June 2020 Planning Commission

Engineering Comments Summary

**SPRINGDALE PLANNING COMMISSION
COUNCIL CHAMBERS
201 SPRING
5:00 P.M. JUNE 2, 2020
Tentative Agenda**

To: Planning Commission
From: Staff
Date: June 2, 2020
RE: L20-11 Large Scale Development Williams Tractor

W:\2020\20-2104 - Springdale, AR - The Crossings\Design Drawings\202104-SP.dwg, PRINTED ON: May 21, 2020 @ 2:26 PM

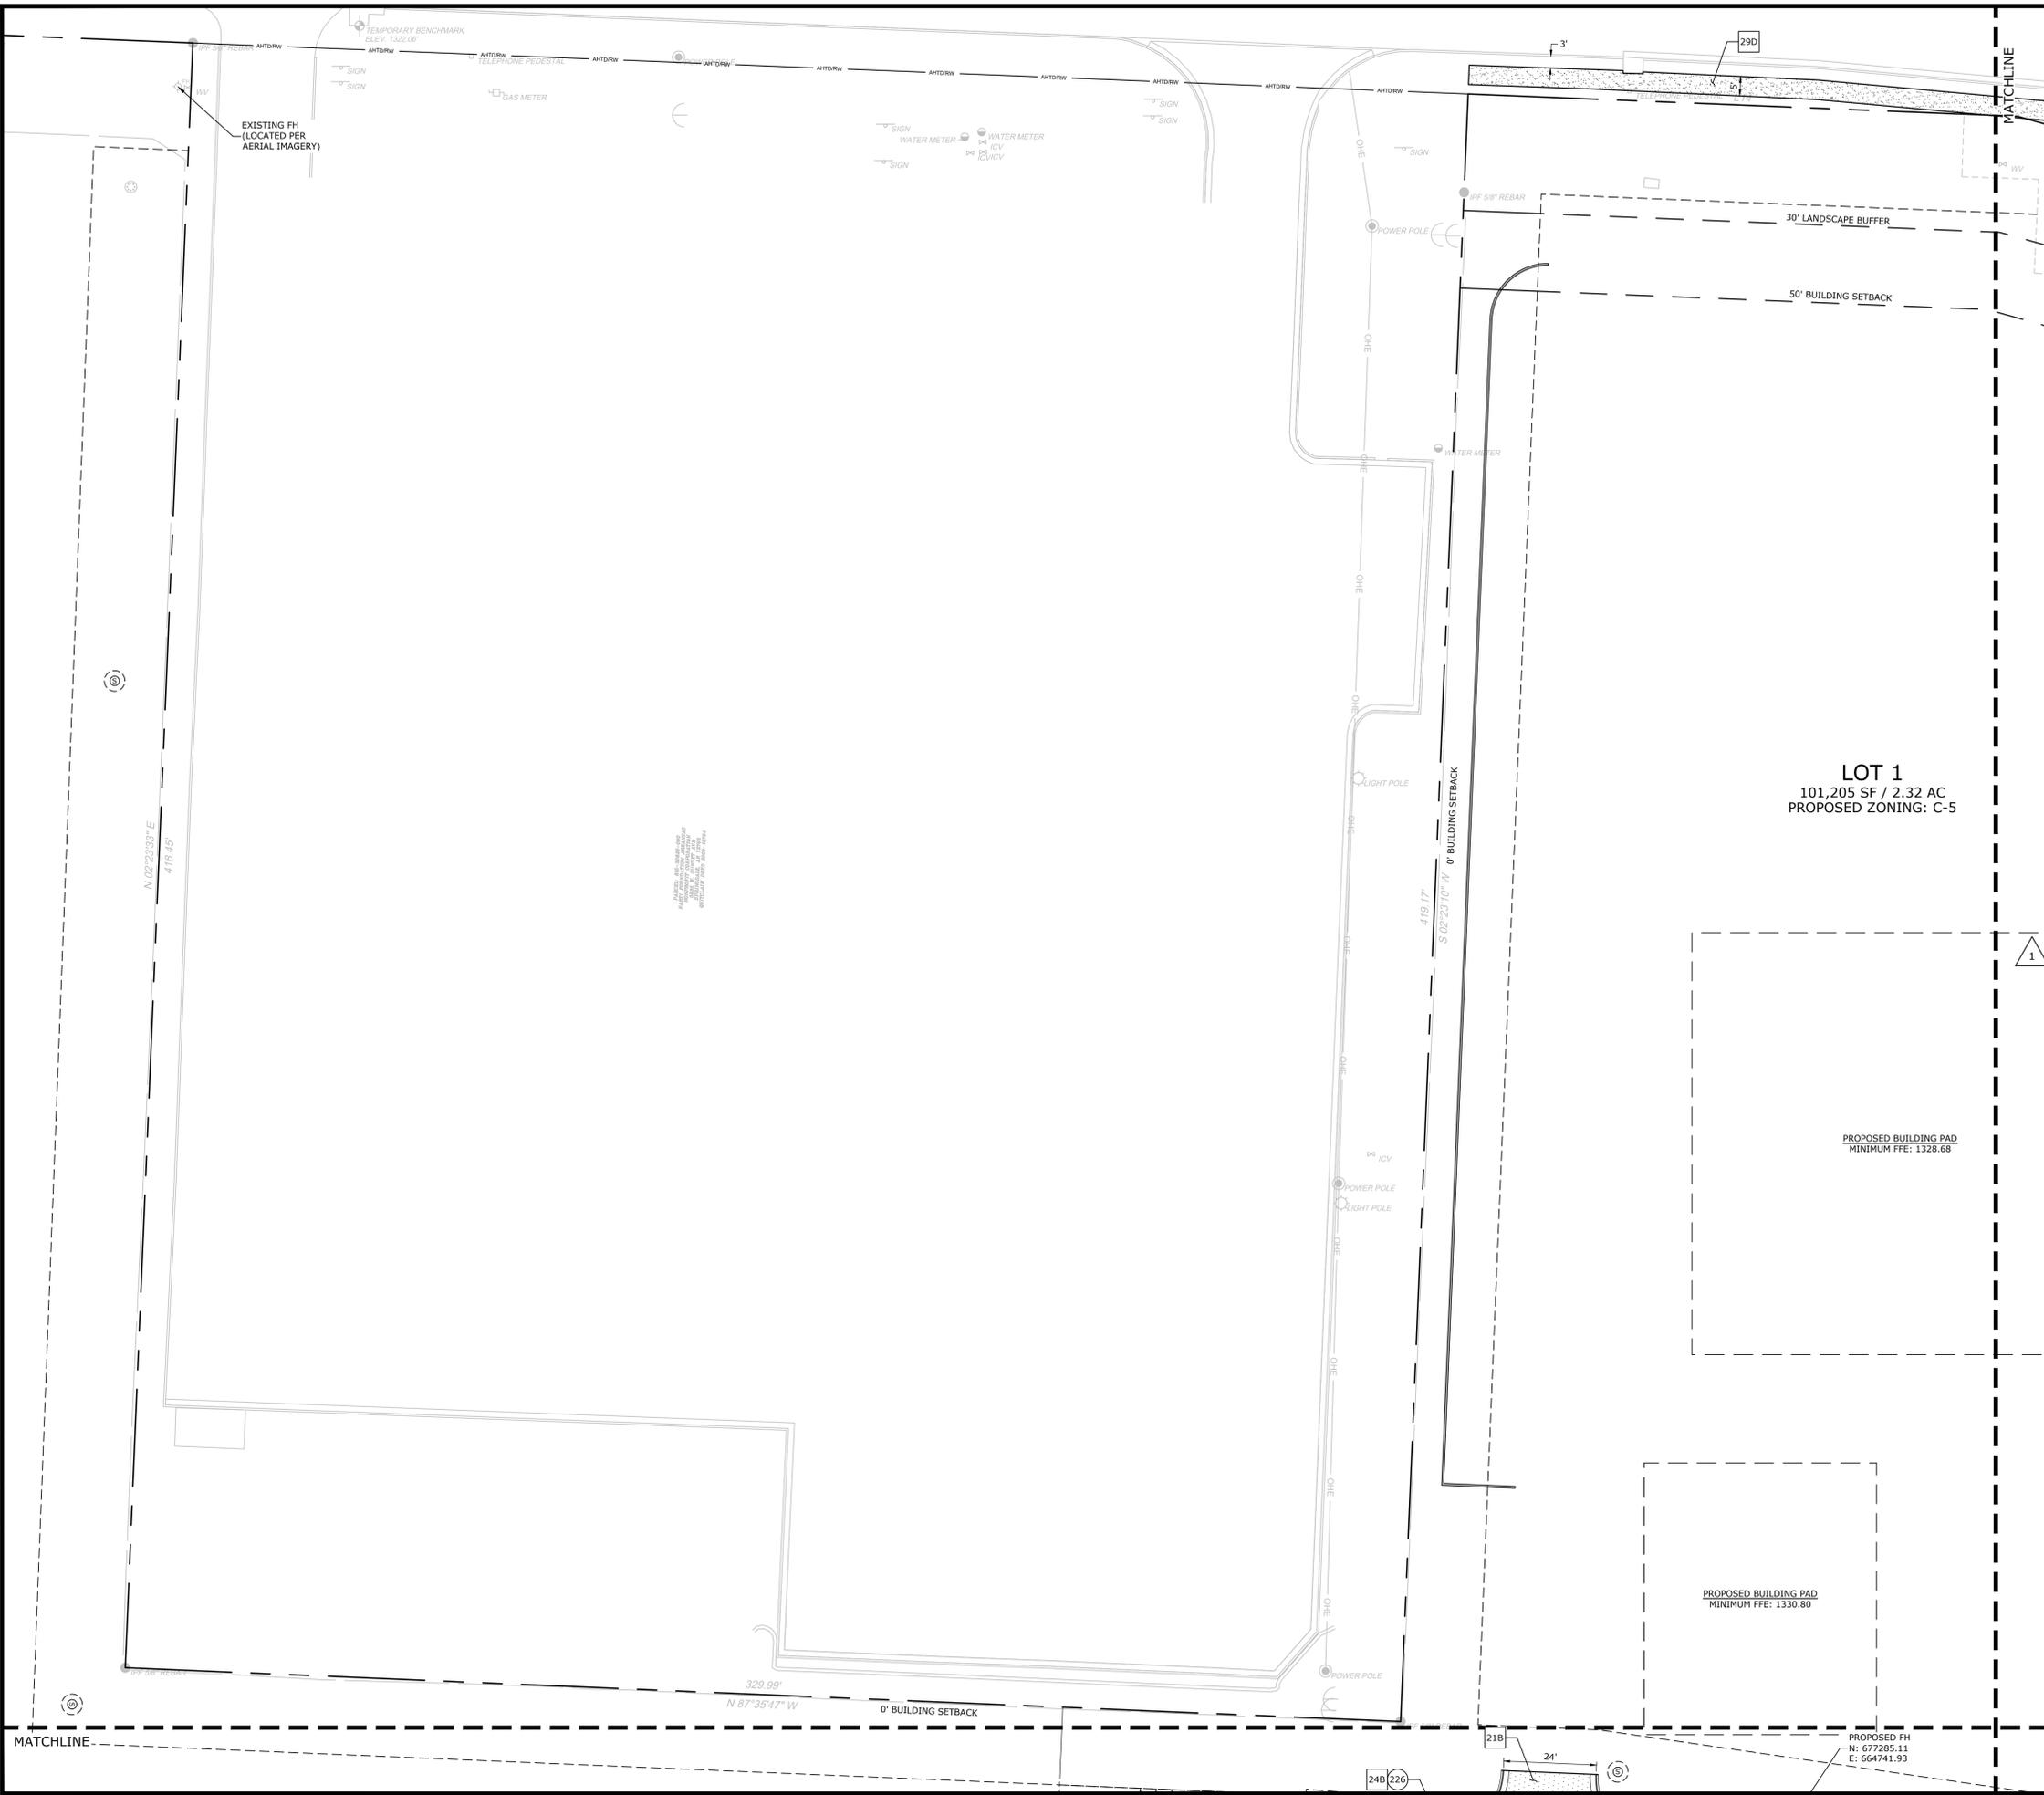
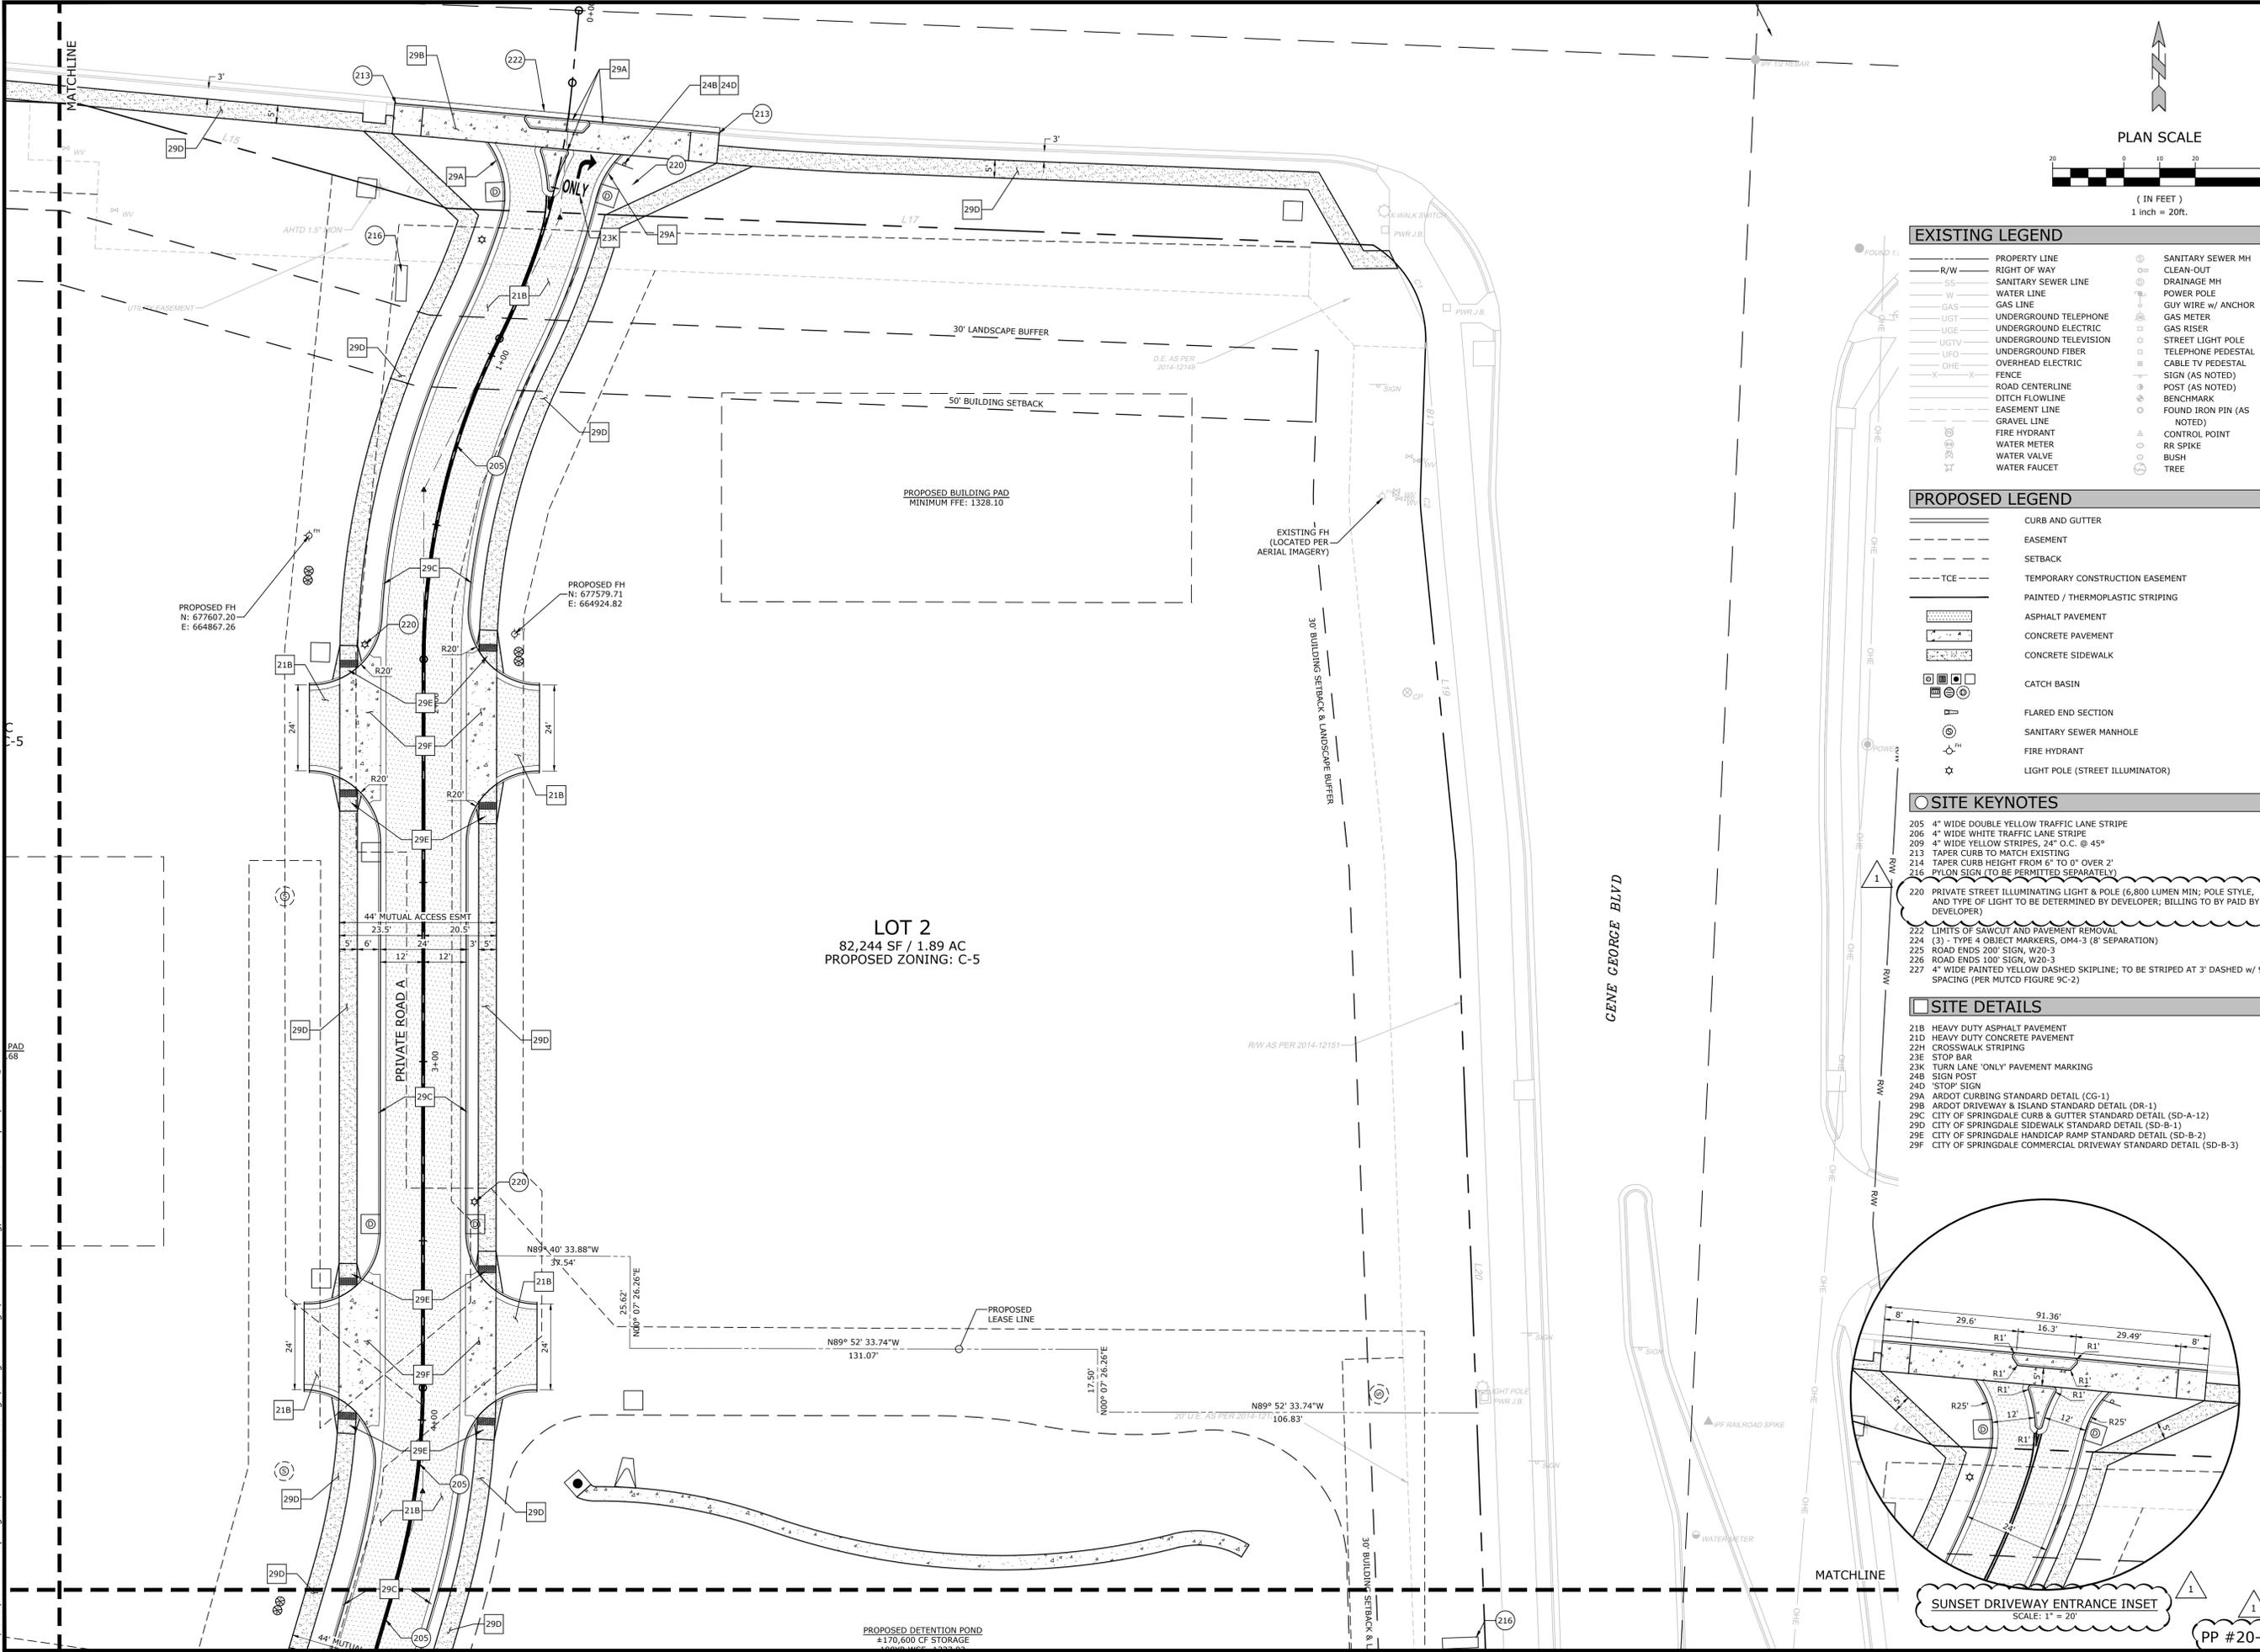
- Need to show proposed/existing streetlights
- Submit Grading Permit application

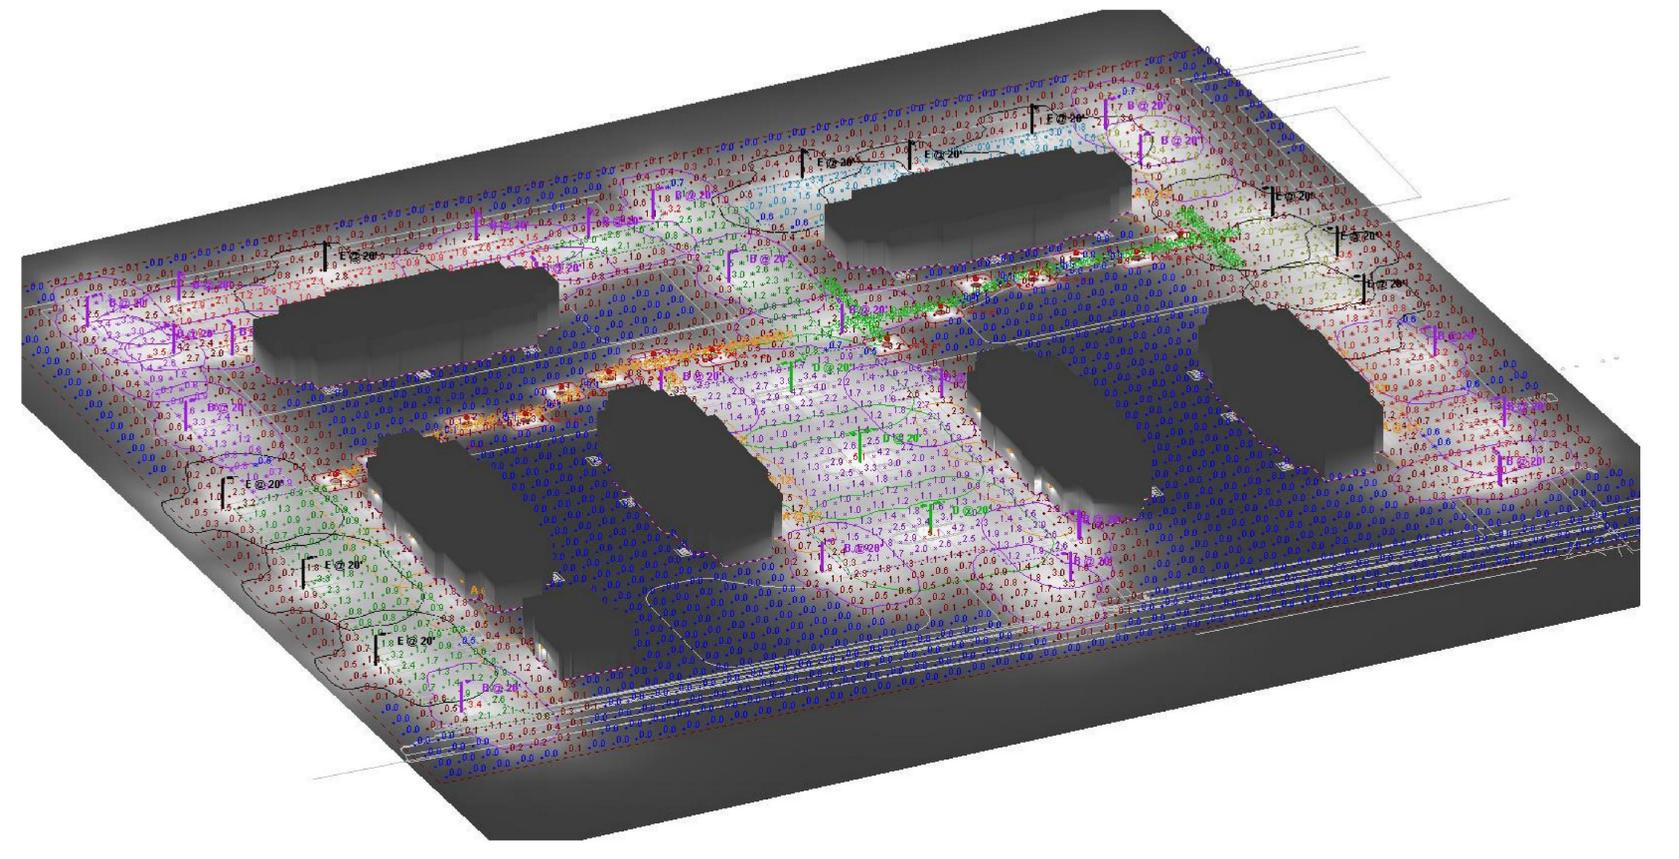
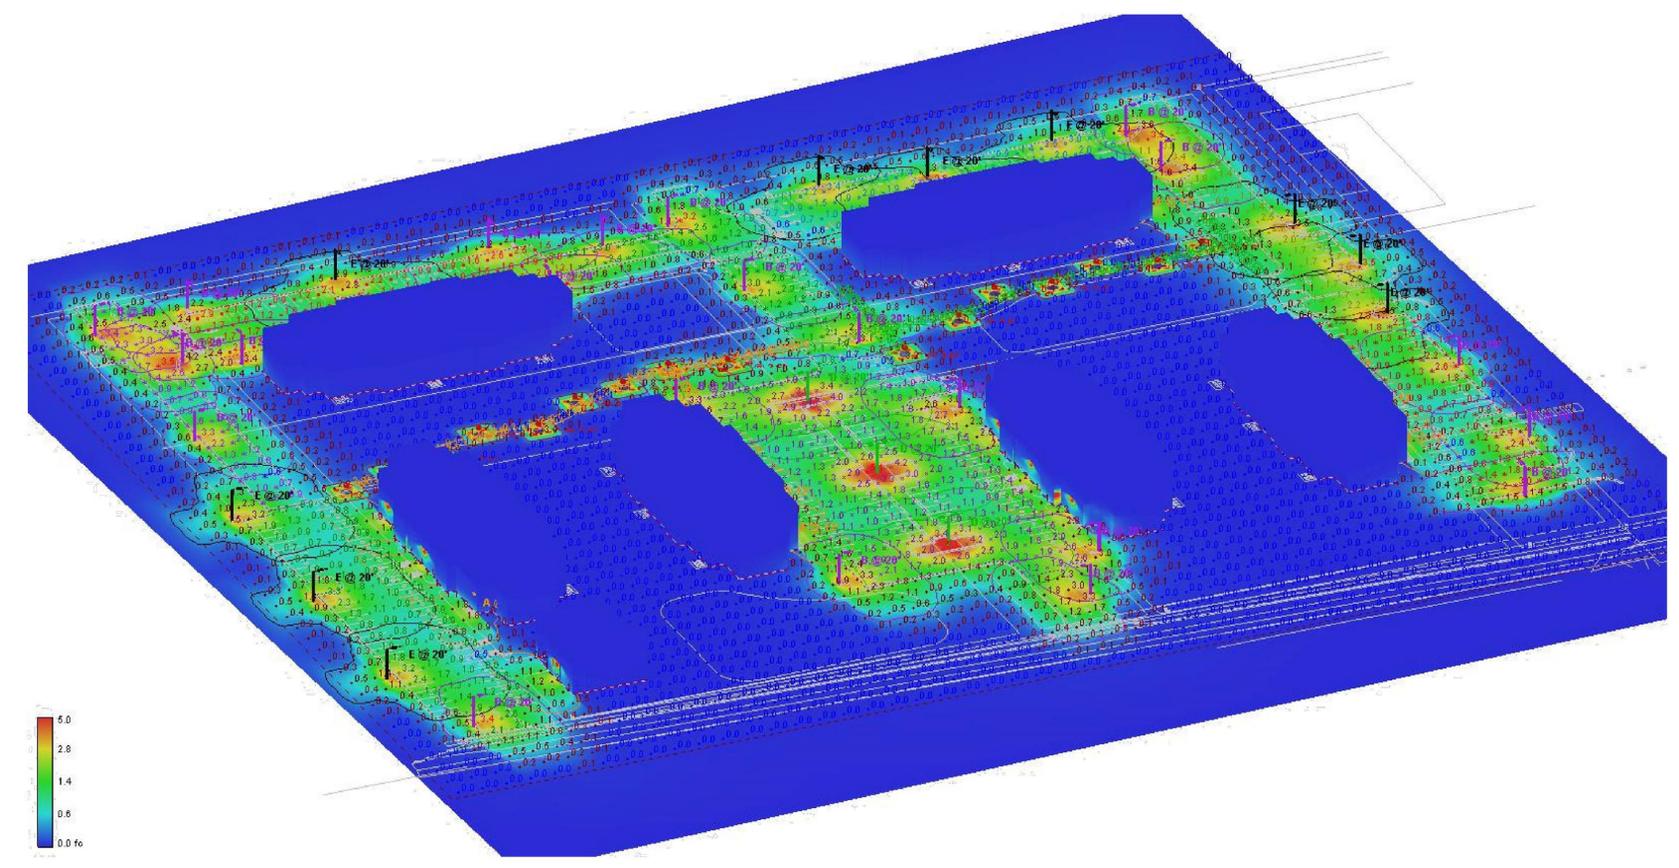
- Show concrete pipe in outlet detail and revise drainage report where it mentions HDPE
- Photometric plan is not legible

- ~~Add note to determine if the light is designed for area parking lot lights or as a street illuminator~~
- Include a note stating if the lights are public or private lights and who will be responsible for maintenance and billing
